CONTRACT TITLE: K_08 REHABILITATION OF SAUDI MATERNITY HOSPITAL

Identification number: CIG 94103090A7

ASKED QUESTIONS AND CLARIFICATIONS

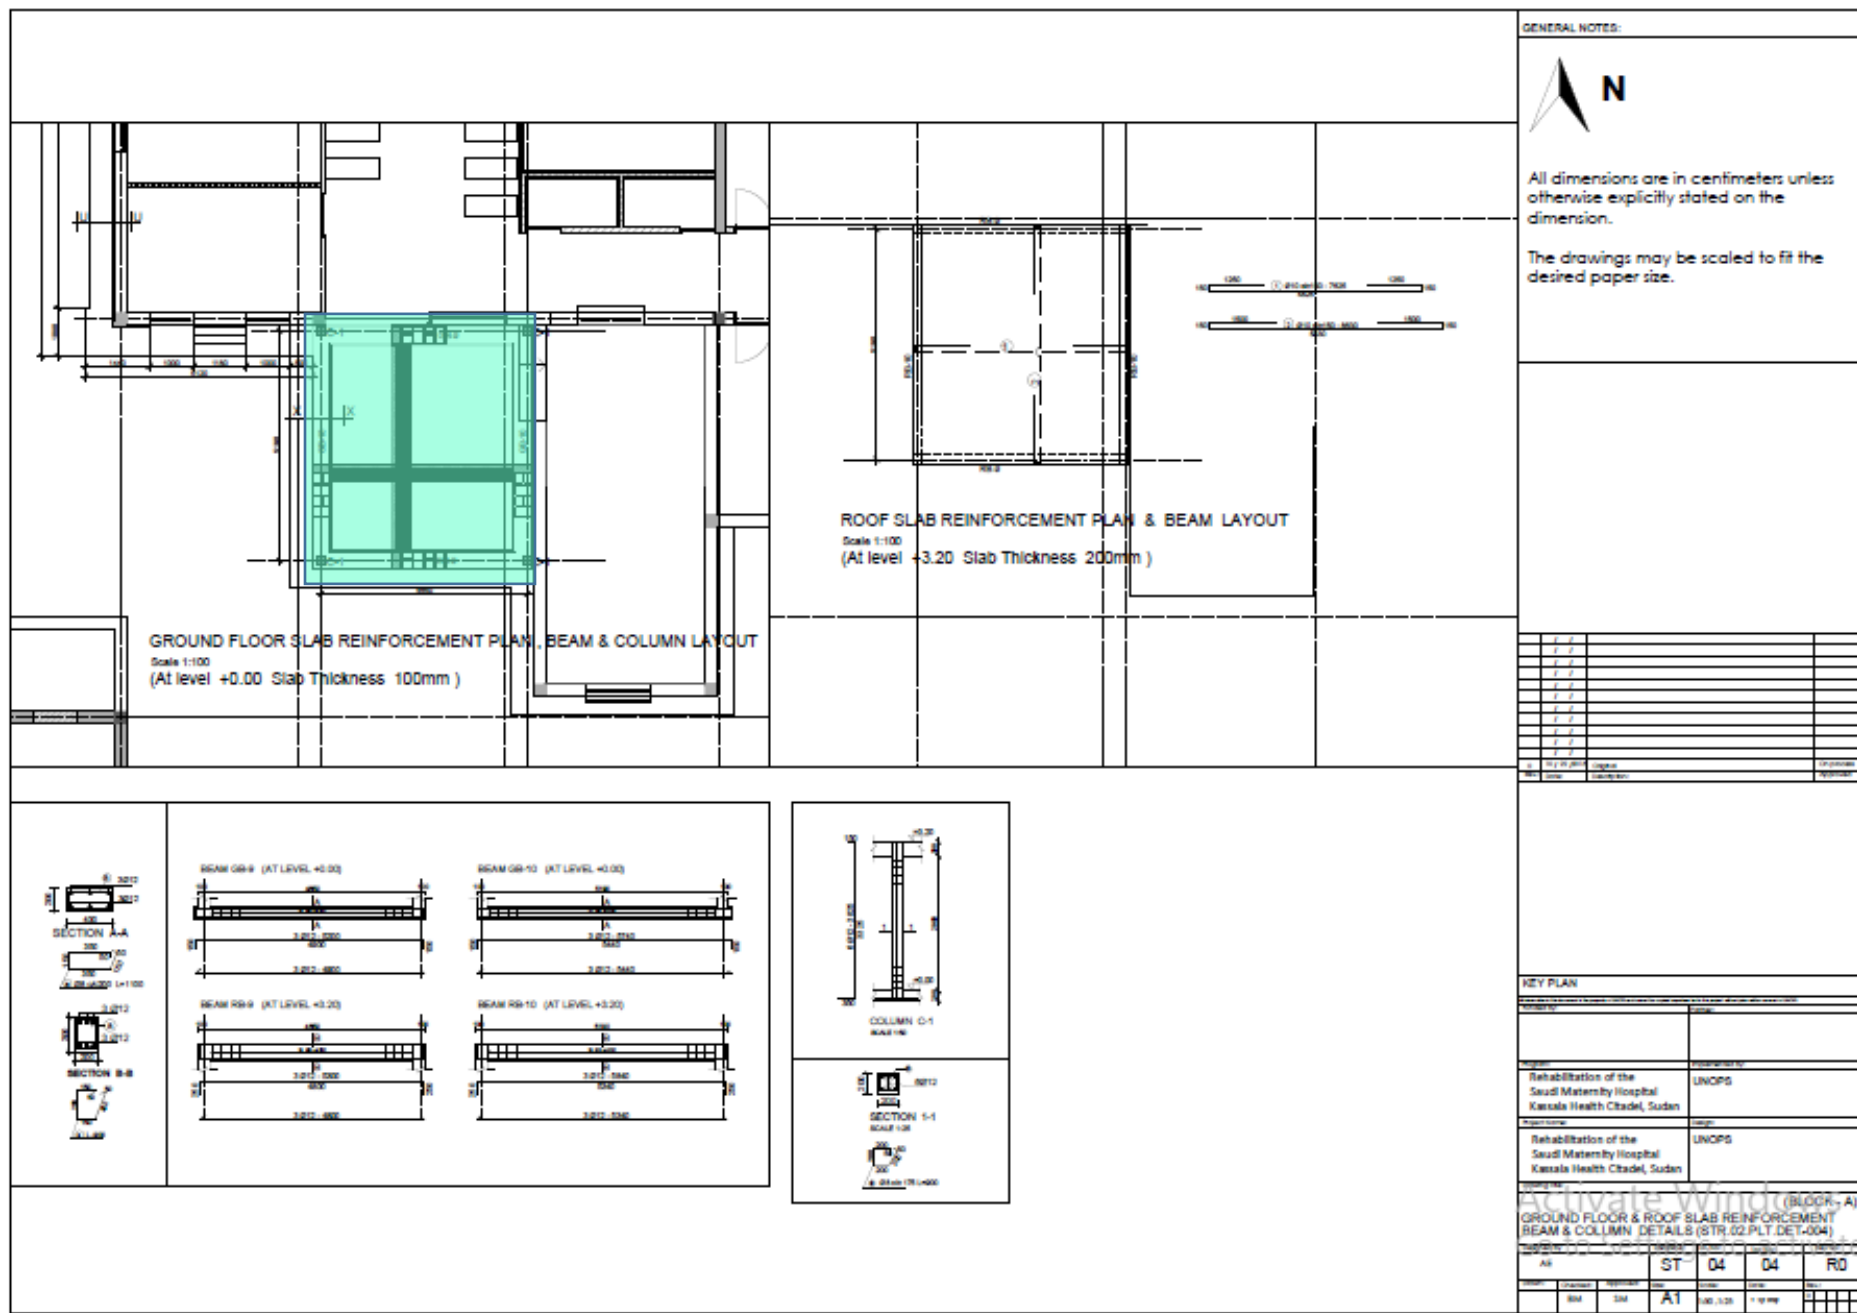
- Item No.3.1.8 Masonry, the unit of measure should be in M3 not M2?

- It has been treated as ordinary masonry wall in m2 (Length X Height), for more details please see drawing No:
VOLUME 5 DESIGN Unpack 3 02-Engineering 02-Struc Drawings STR.02.PLT.DET002-Block A & STR.02.PLT.DET003-Block A

Ground Floor - Blocks C, J, K and L

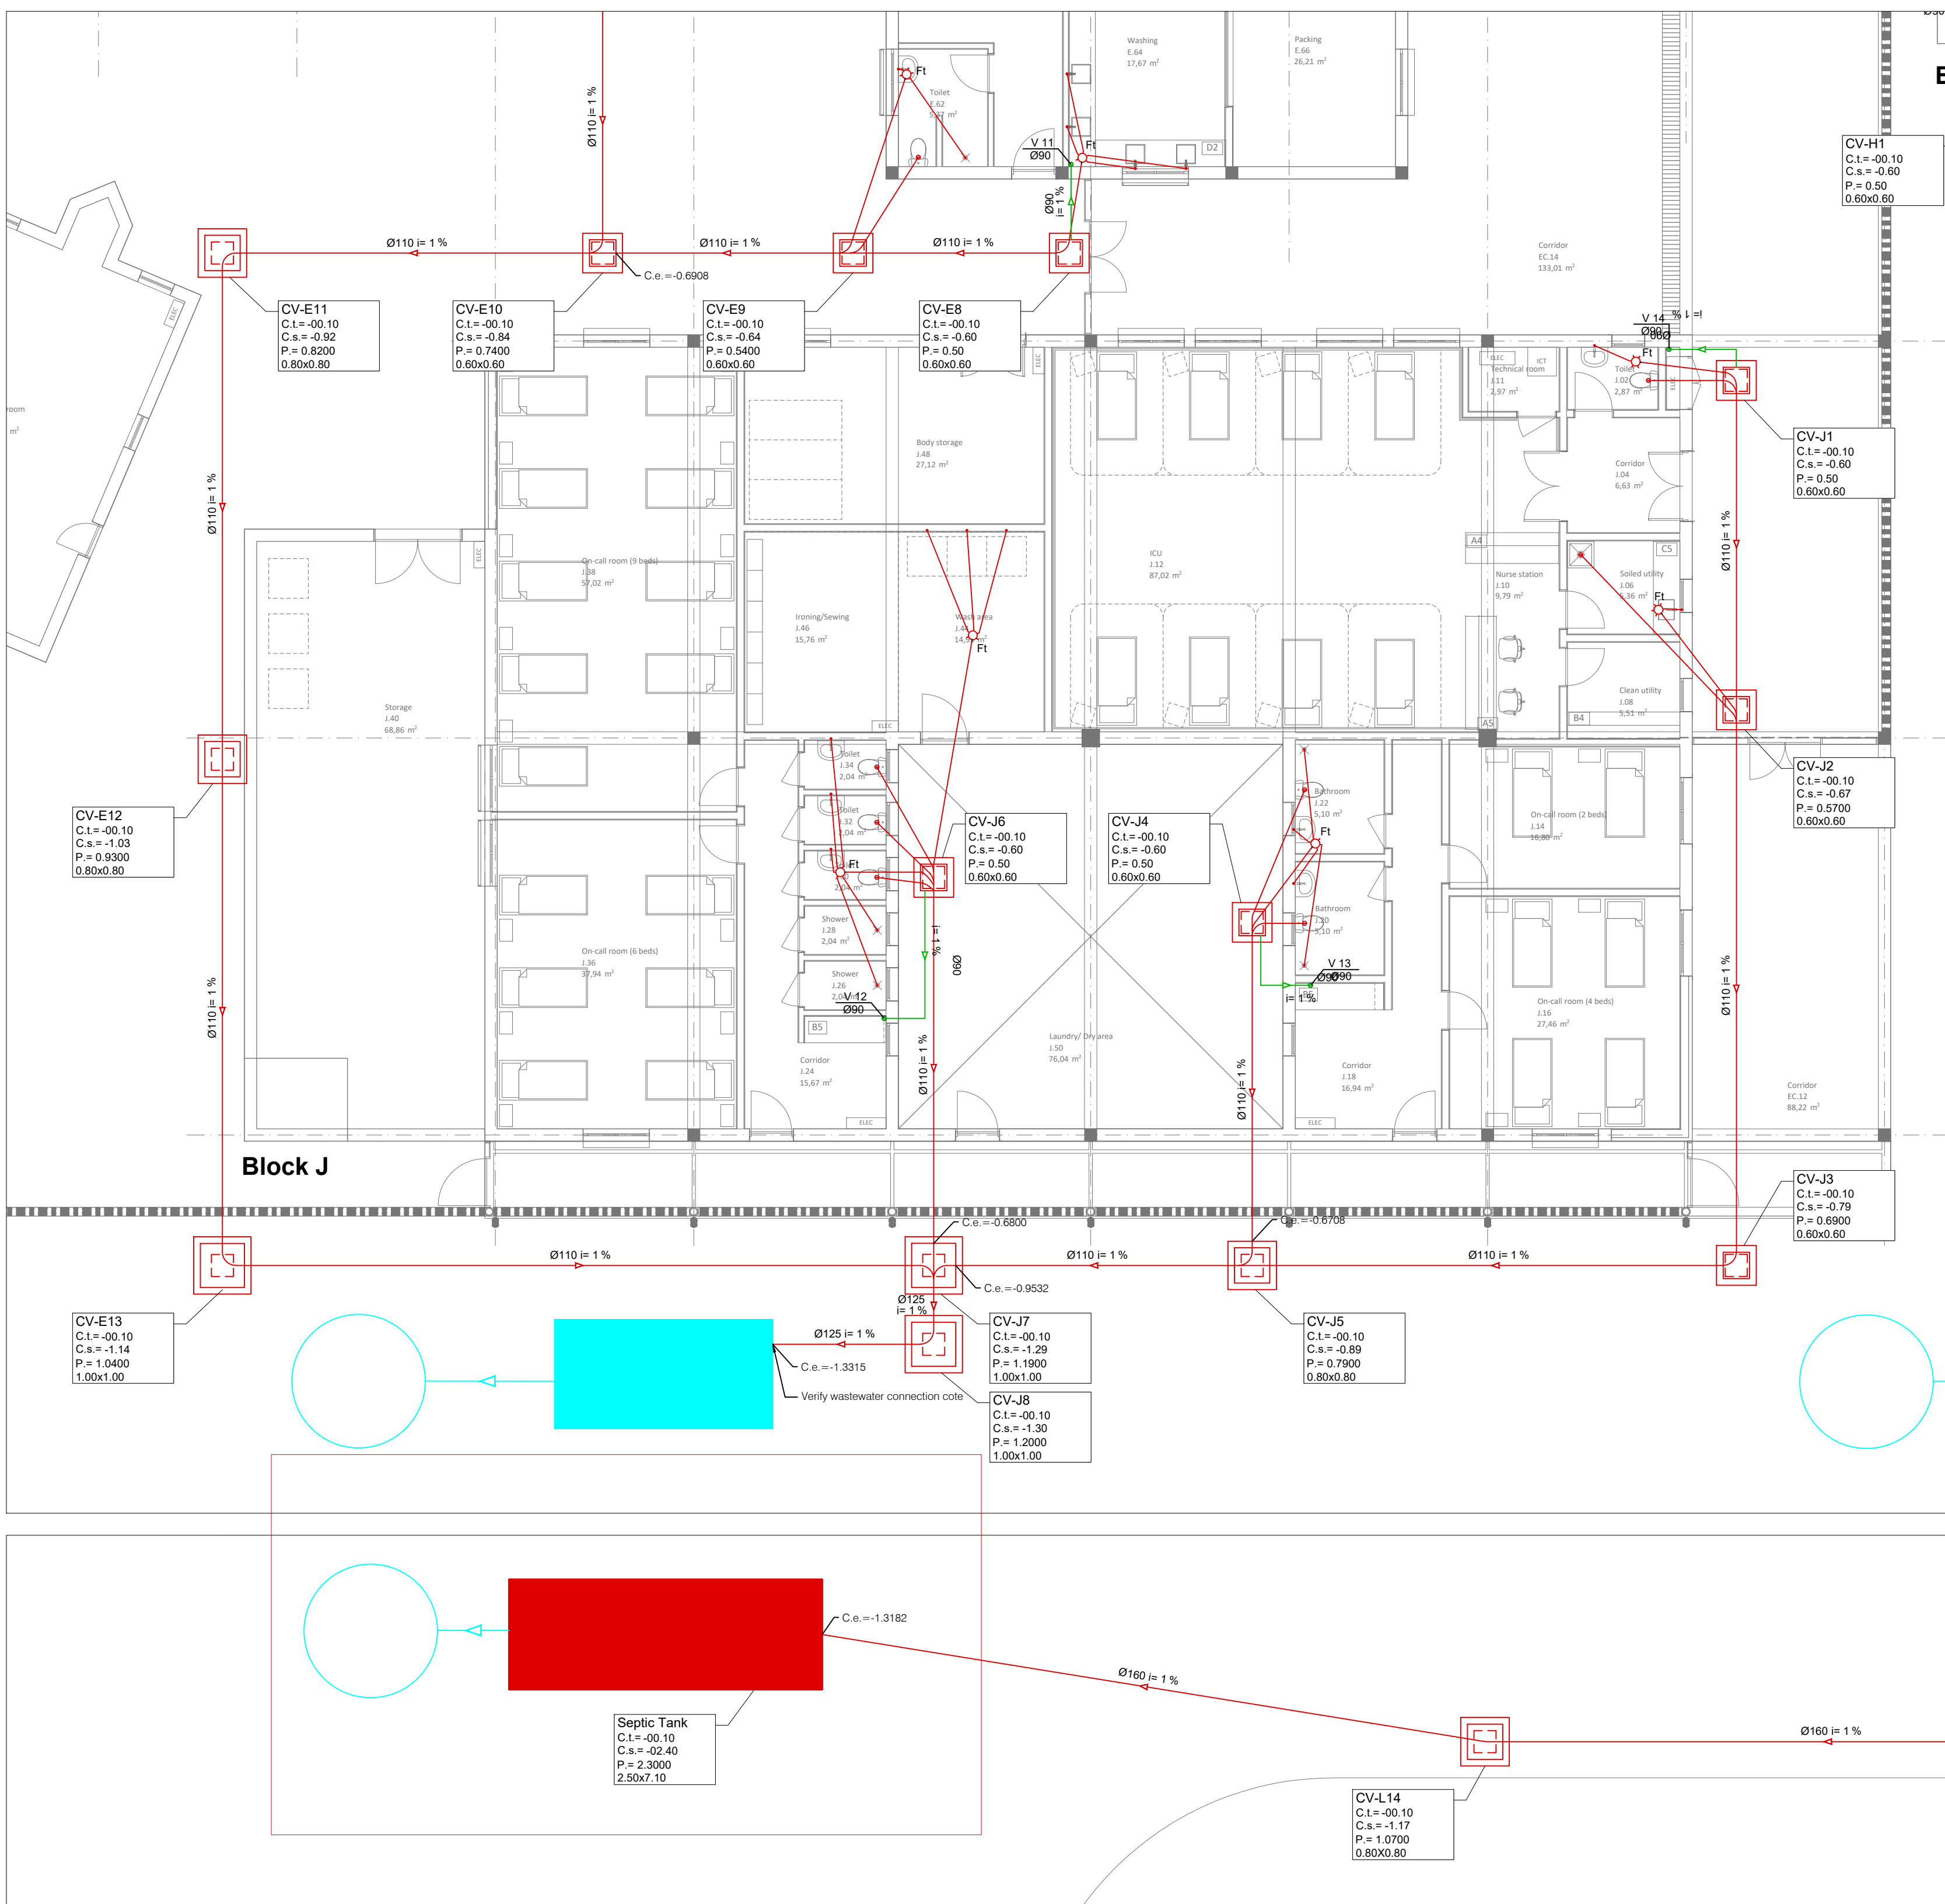
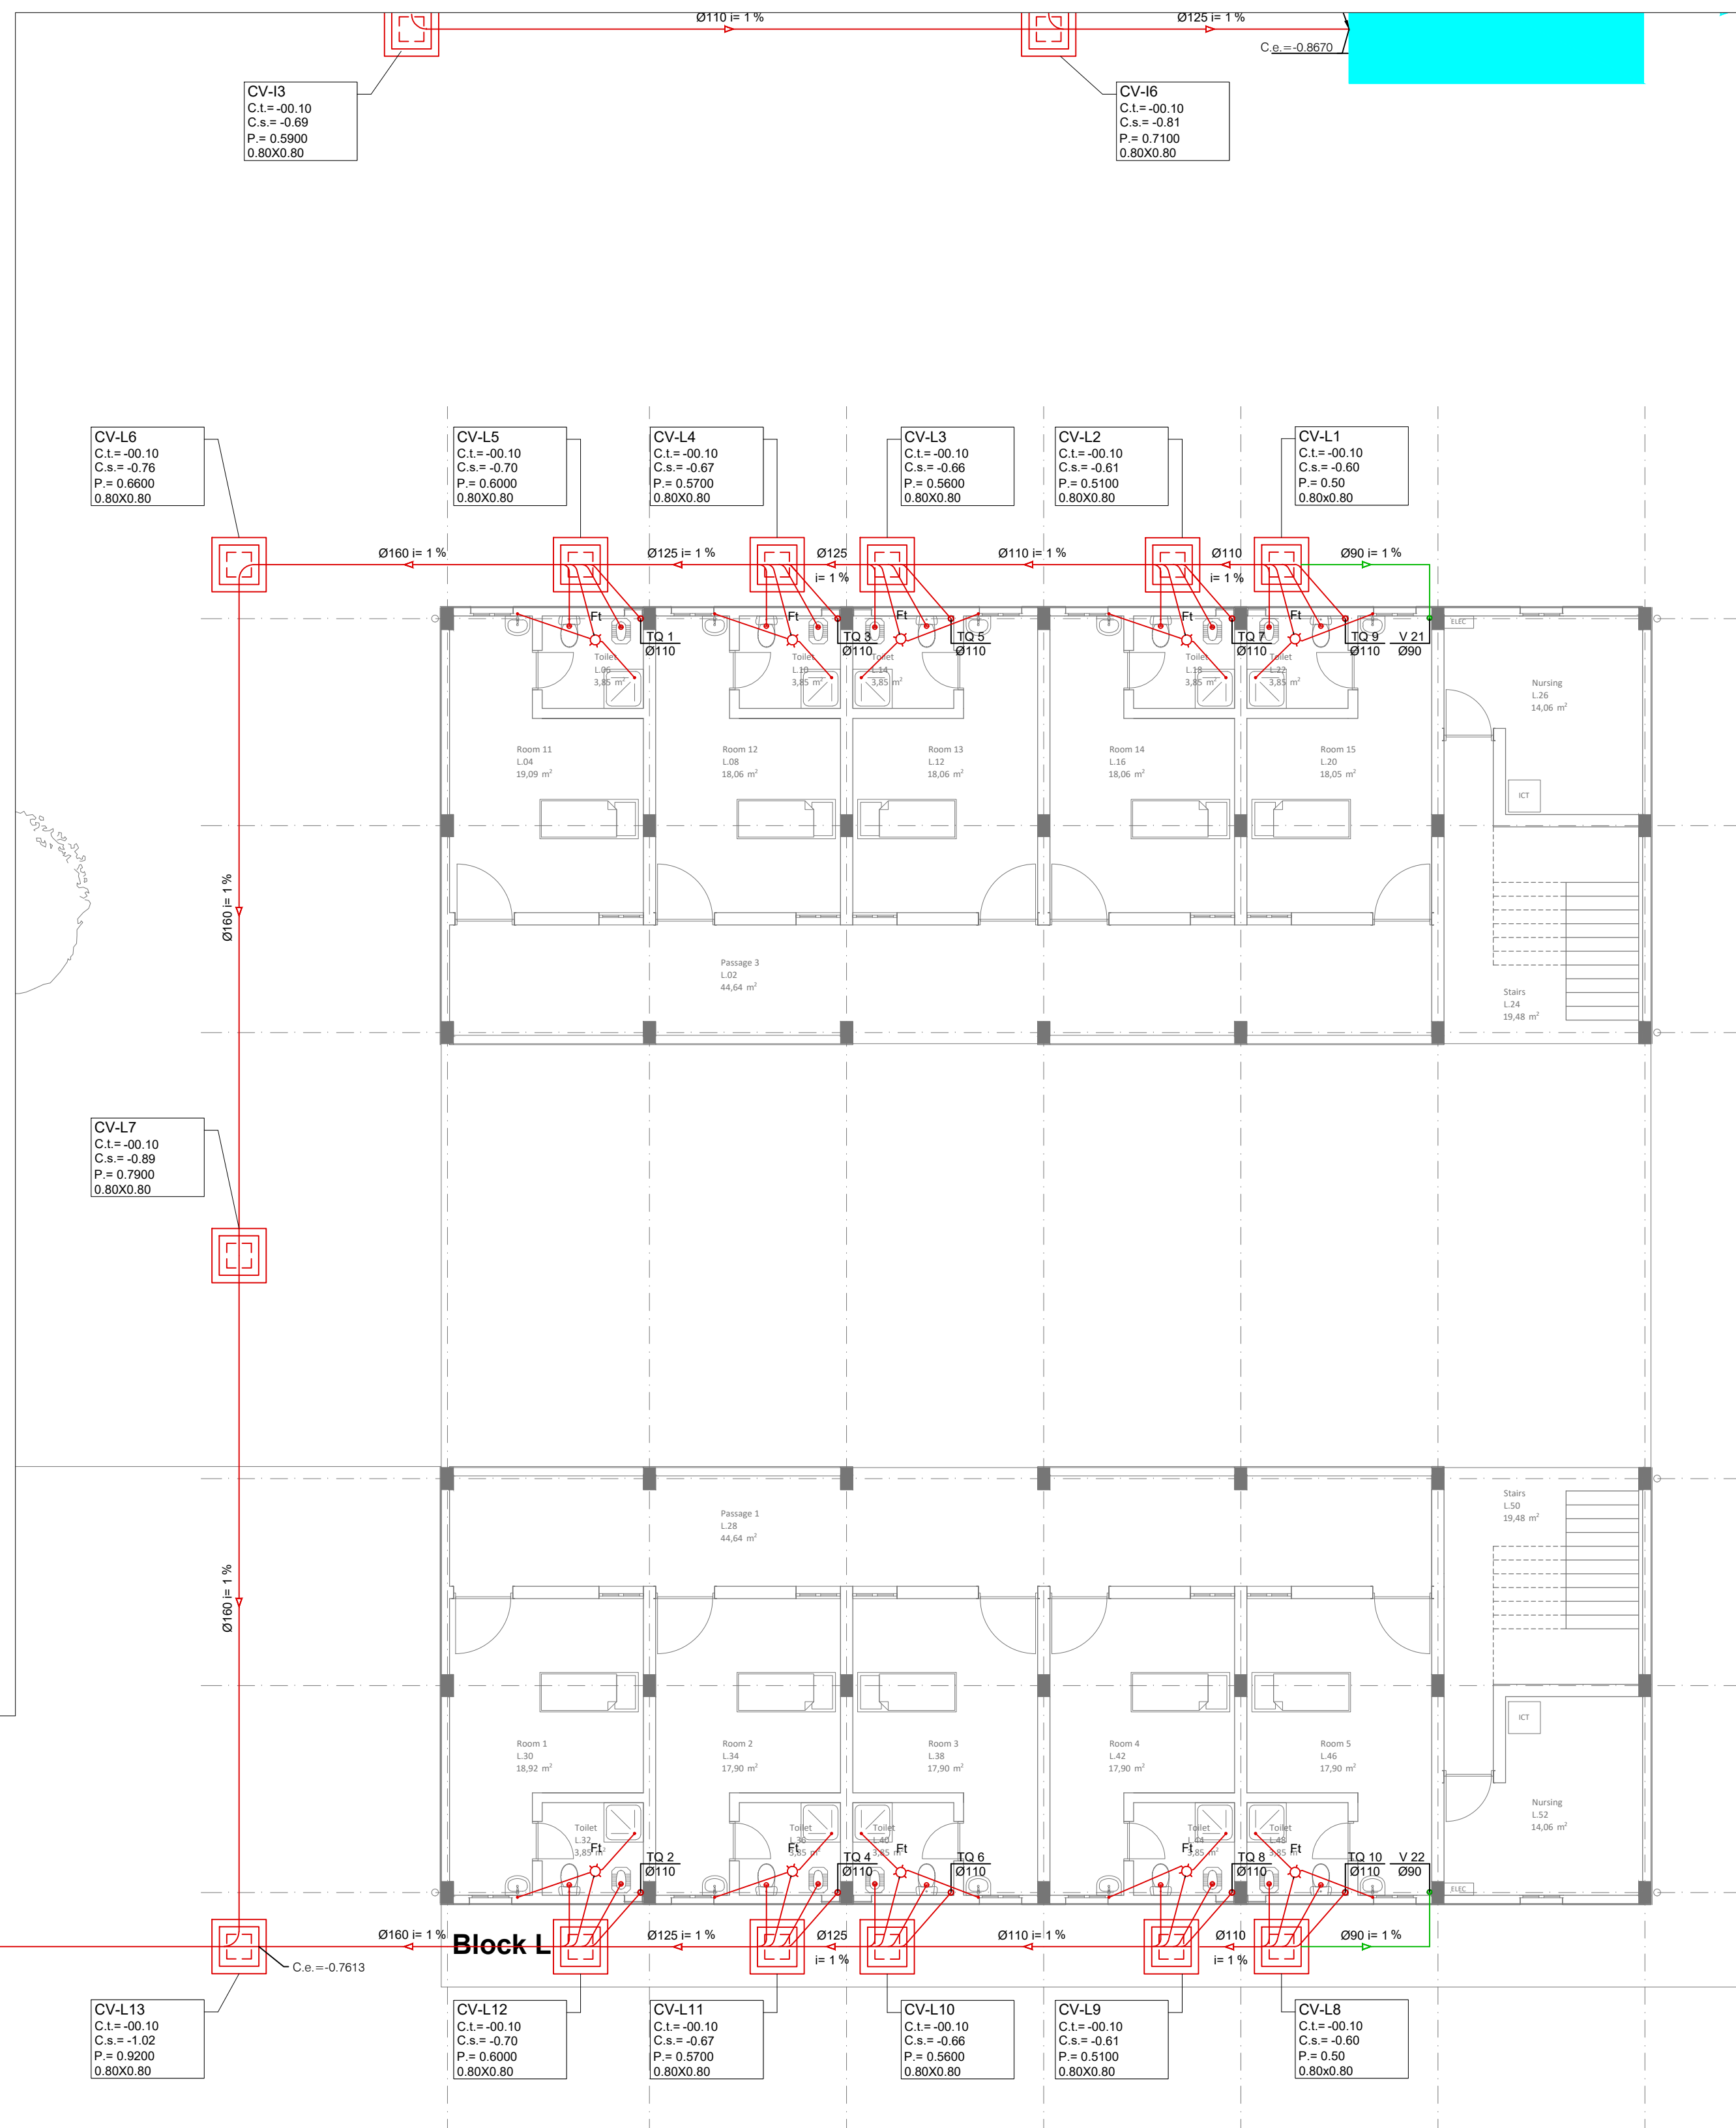
We kindly ask you to specify the dimension of the septic tank (item No.5.1.2.6 – waste water- Block L).

- The dimension of the septic tank is (7.10 L X 2.50 W X 2.30 D), for more confirmation please see drawing No:
 - VOLUME 5 DESIGN Unpack 7 02-Engineering 05-Hydraulic Drawings HWD.01.PLT003.PDF.
 - Drawing name: Ground Floor-Blocks C, J, K and L.
 - And also you can see attached PDF sheet (HWD.01.PLT.003-Ground Floor C_J_K_L) in red rectangular at the Centre.
